PUBLIC NOTICE OF HAZARDOUS WASTE PERMIT RENEWAL

Re: Answer and Request for
Hearing
Union Oil Company of
California, Respondent
Docket No. V-W-87R-015

UNOCAL RESPONSE
TO ILLINOIS ENVIRONMENTAL PROTECTION AGENCY
JUNE 26, 1986 PRE-ENFORCEMENT CONFERENCE LETTER
ATTACHMENT A

FIGURE 1

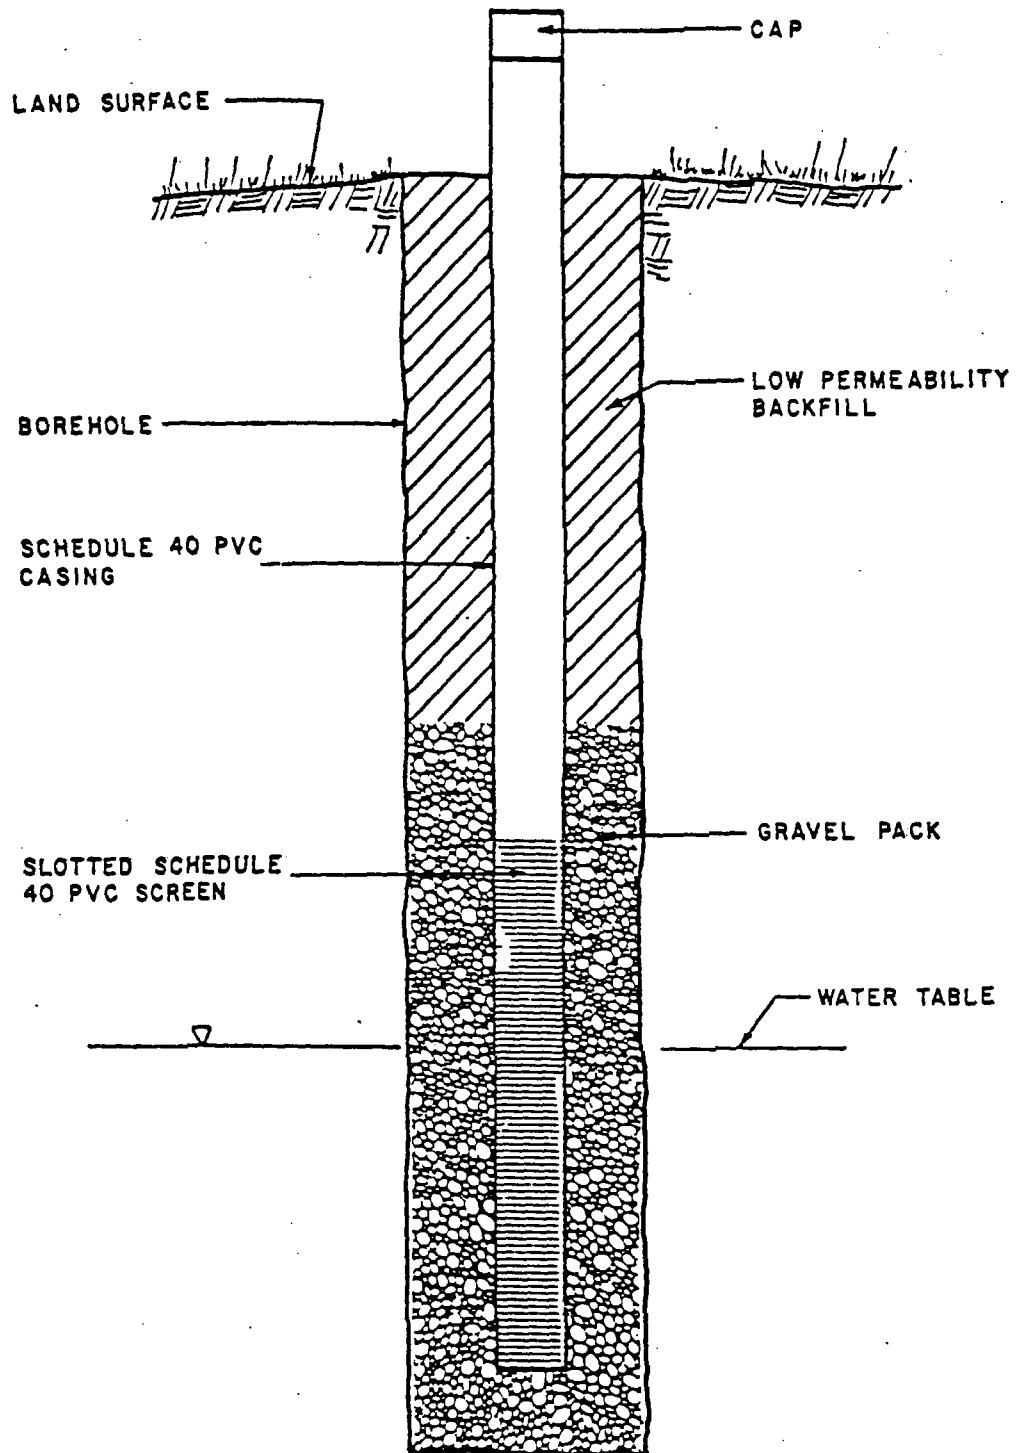
3. Pursuant to 35 Ill. Adm. Code 725.191(a)(1), groundwater monitoring system must consist of an adequate number of upgradient monitoring wells. Upgradient wells must be installed that provide representative background samples for the dolomite aquifer and any hydraulically connected unconsolidated deposits. The construction of these wells should be such that the aquifer and the unconsolidated deposits can be monitored exclusively. This

will require well screens of no more than ten feet.

dating an adequate depth of water within the well to facilitate sampling. However, 10 or 20 foot well screens will also provide perfectly acceptable results.

slurry". The abbreviation e.g. means "for example" and implies no specificity to the material other than being of suitably low permeability. Additionally, the USEPA, December 1980 publication SW-611 recommends low permeability backfill (see Figure 1). Inspection of Table 4 in Attachment 1 shows that the media calculated permeability of the native clay backfill is approximately 2×10^{-7} cm/sec. This is considered a low permeability. Additionally, excluding the surficial cement plug and bentonite seal over the sand pack, there is a minimum of 30 feet of low permeability clay backfill which protects the groundwater sample and groundwater from surficial contamination.

FIGURE 10

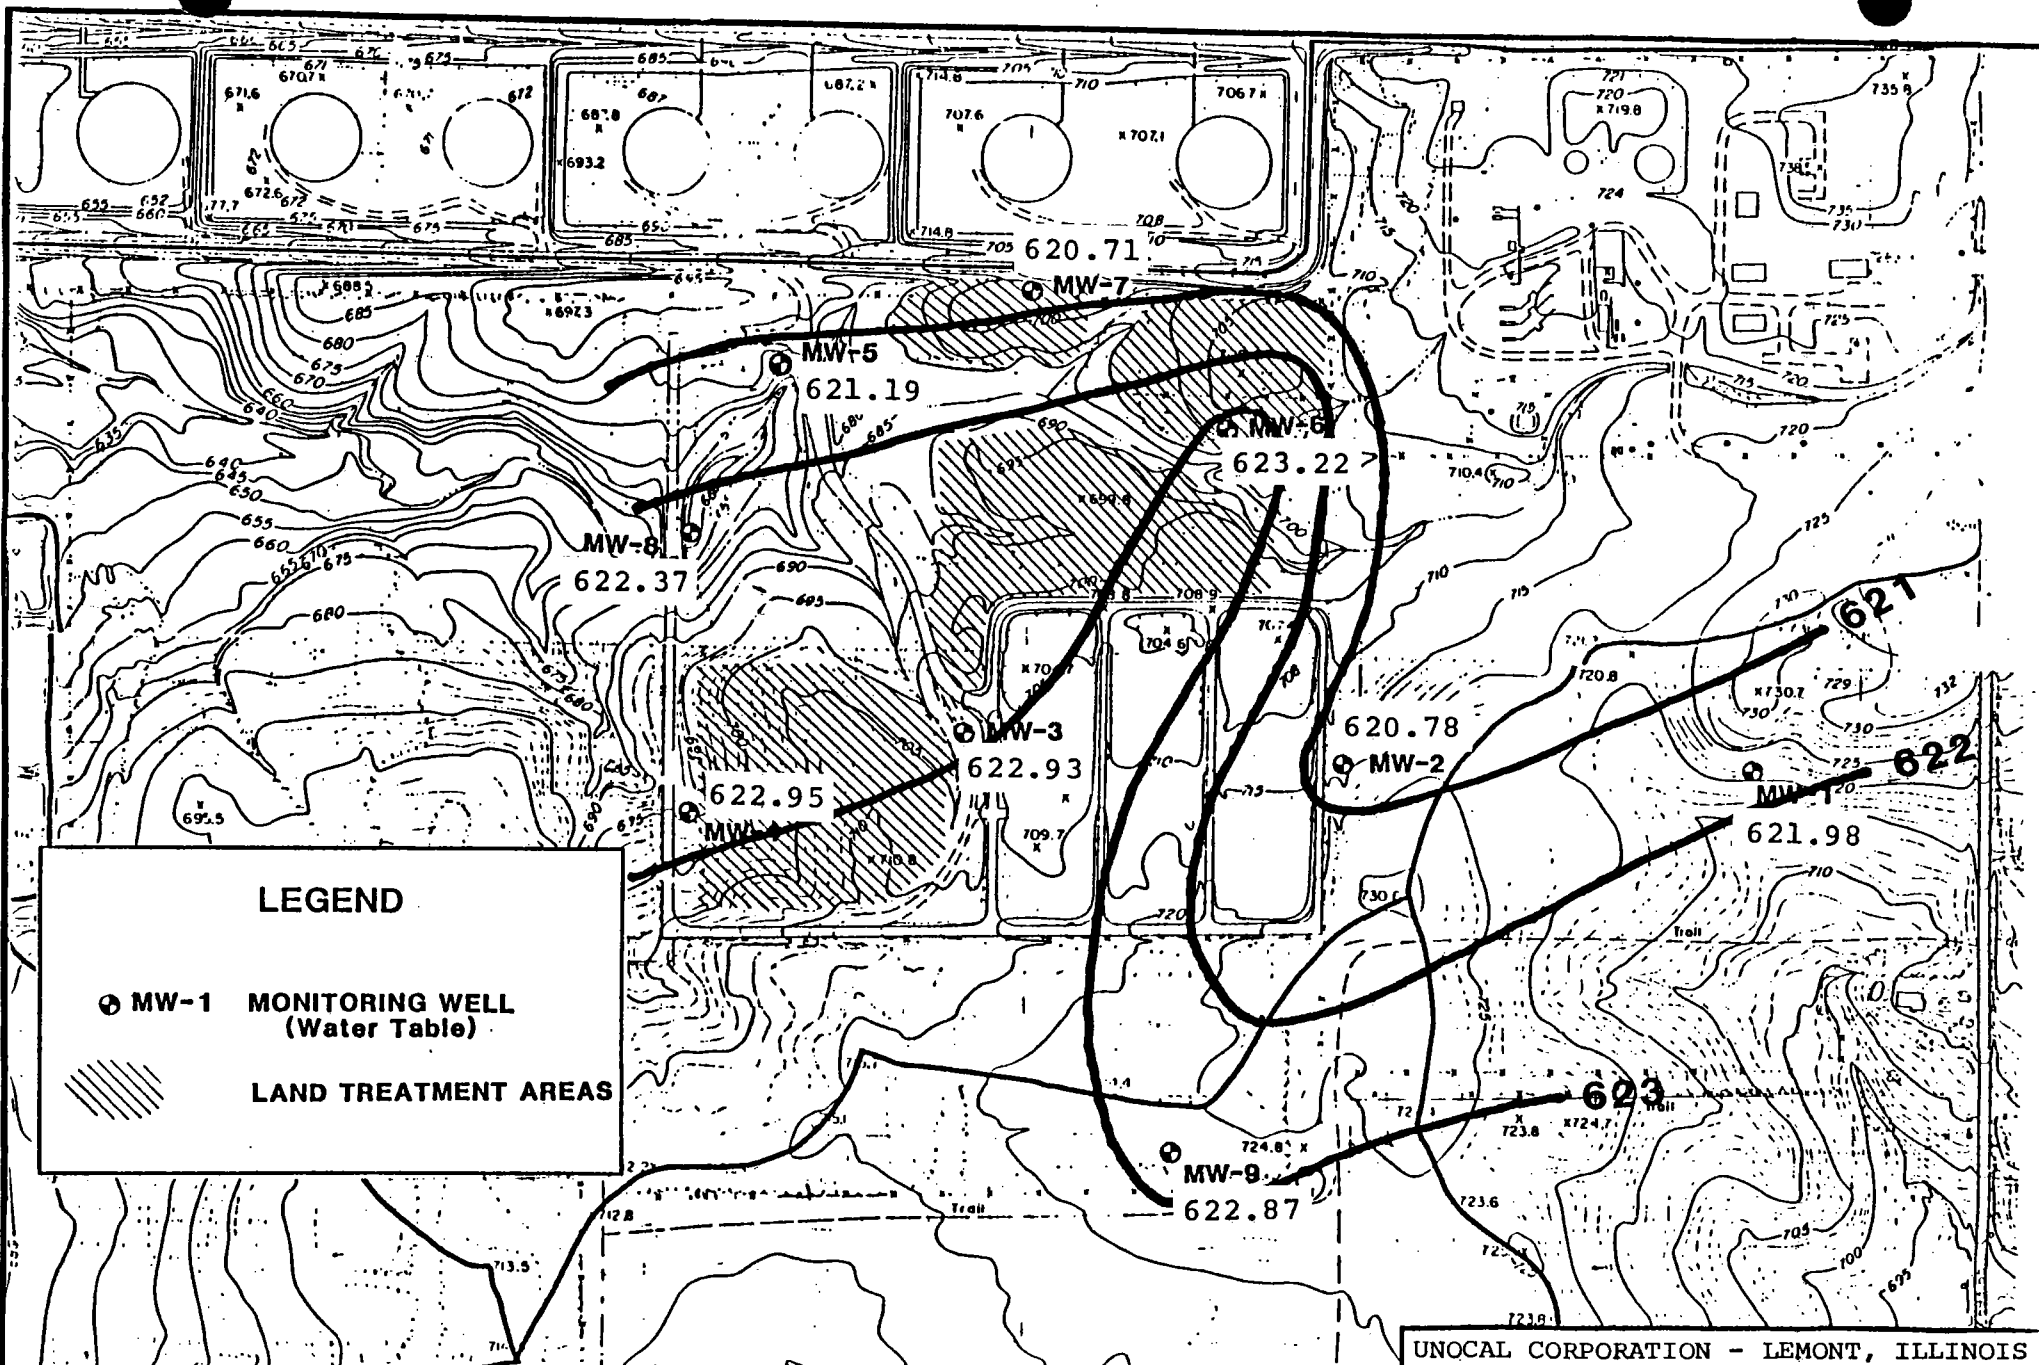
4. Pursuant to 35 Ill. Adm. Code 725.191(a)(2), the groundwater monitoring system must consist of an adequate number of downgradient monitoring wells. The number, depths and locations of the current wells are inadequate to immediately detect any statistically significant amounts of hazardous waste or hazardous waste constituents in the groundwater for the following reasons:

- a. Downgradient wells are, at a minimum, 500 feet apart. The facility must provide a justification for this well spacing and provide additional wells, if necessary.

Using the water level measurements (Table 3) for the saturated zone, Figure 10, 11, 12, 13 and 14 were prepared showing the ground water contours underlying the land treatment areas. Based upon water level measurements and the groundwater contours shown on Figures 10 through 14, the net flow of groundwater in the site vicinity is to the northwest. The maximum hydraulic gradient calculated from the groundwater contours for each sampling period is presented below:

<u>DATE OF MEASUREMENT</u>	<u>HYDRAULIC GRADIENT</u>	<u>REFER TO FIGURE #</u>
6-18-84	0.0050	10
9-13-84	0.0087	11
11-28-84	0.0077	12
6-03-85	0.0043	13
11-13-85	0.0043	14
